BECHTEL	Mechanical Handling Data Sheet Top Running, Double Girder	**CM** ⚠4	Data Sheet No. 24590-HLW-M0D-HSH-00181 Rev. 4 Plant Item No. 24590-HLW-MJ-HSH-CRN-00014

Project	RPP-WTP	Description	Melter 2 Cave Main Crane
Project No.	24590	Supporting Calculation No.	N/A
Planning Area		Associated Drawing No.	N/A
System No.	HSH	Associated Specification No.	24590-WTP-3PS-MJKG-T0003
Building No.	30	Associated MR No.	24590-QL-MRA-MJKG-00002
Quality Level	▶CM ⚠4	Associated MHD No.	24590-HLW-M7-HSH-00002002
Seismic Category	SC-II		
Function	Melter Cave 2 Support

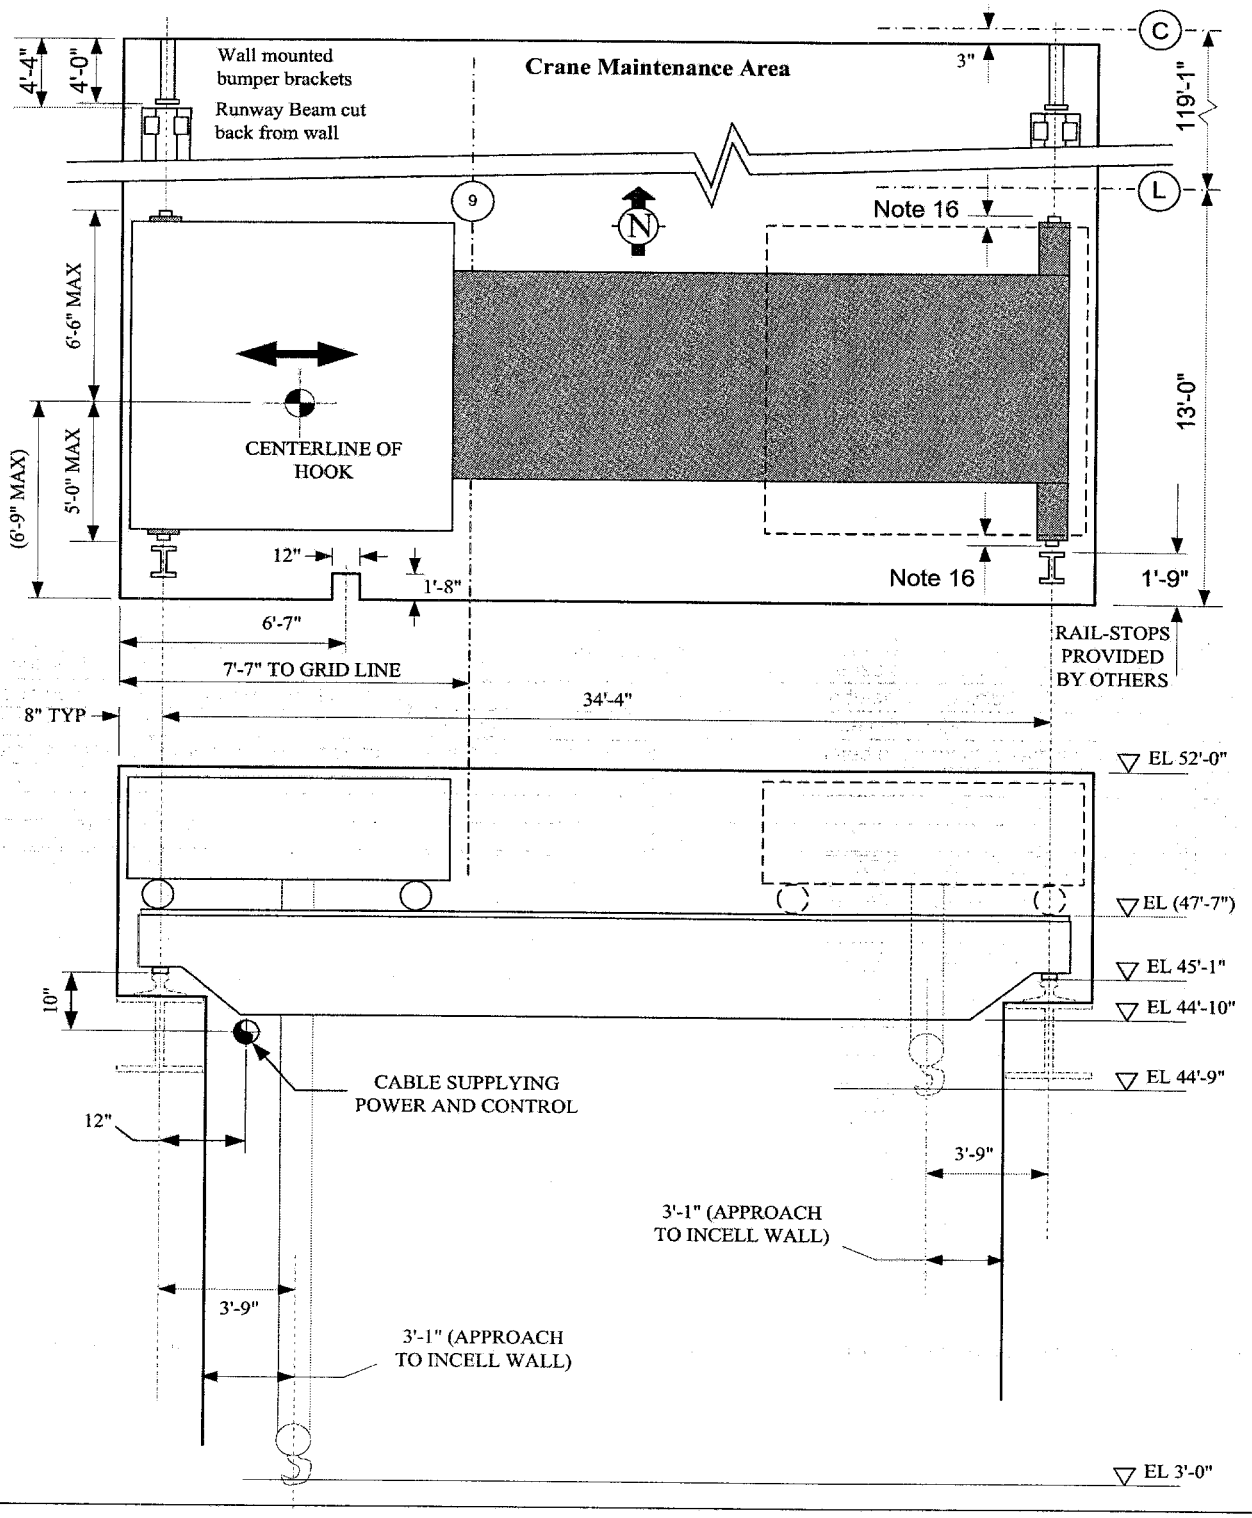
16. ► Trolley may not extend past fully compressed end truck bumper. △4
17. ► Revised sketch on page 3, changed Safety Classification from SDS to APC; Quality Level changed from QL to CM and revised environmental conditions △4
